**Travilah Square, Preliminary Plan Amendment No. 12011034B and Limited Site Plan Amendment, No. 82013007A**

**Completed: 9/30/16**

- Request for preliminary plan and site plan amendments to replace two existing structures with a new 16,300-square-foot multi-tenant retail building;
- Location: Southeast corner of the Darnestown Road/Travilah Road intersection, in the *Great Seneca Science Corridor Master Plan* area;
- 5.56 acres, zoned CR 0.75, C 0.5, R 0.75, H 80;
- Applicant: MFS Travilah LLC & ABS Travilah LLC;
- Applications accepted:  
Preliminary Plan Amendment on 8/3/16;  
Site Plan Amendment on 5/11/16.

Figure 4 Landscaping Plan with two biofilter landscaped facilities.

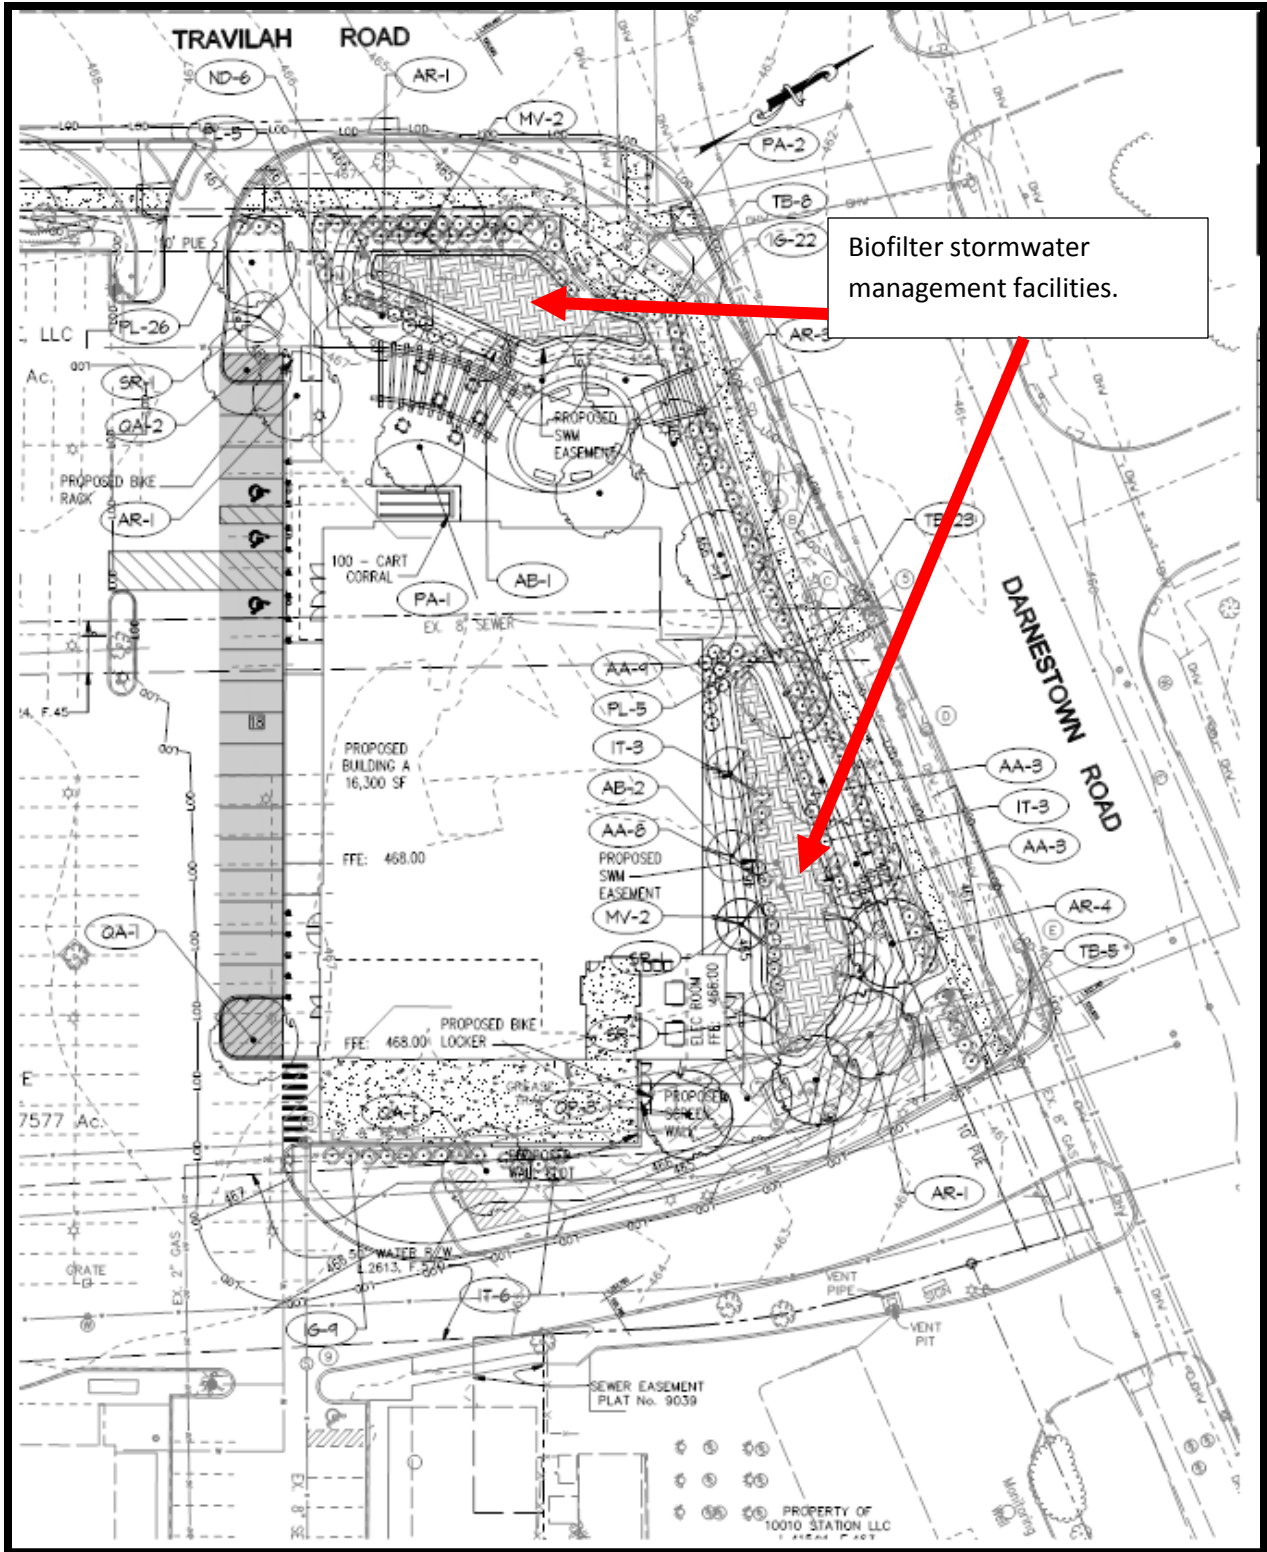
The area for the 18 new parking spaces on the south side of the proposed building contains 3,624 square feet. The Landscaping plan shows 181 square feet of internal pervious area or five percent in two areas adjacent to the new parking spaces. In order to meet the 10 percent requirement, a total of 362 square feet must be provided.

The Landscaping plan shows the new parking facility's area at 3,624 square feet and provision of 25 percent of tree canopy coverage, or 906 square feet. This does not meet the required 30 percent (or 1,087 square feet). The tree canopy coverage must be increased by five percent on the Landscaping plan in relation to the 18 new parking spaces to meet the 30 percent requirement.

The Applicant must provide 181 square feet of additional internal pervious area in relation to the 18 new parking spaces.
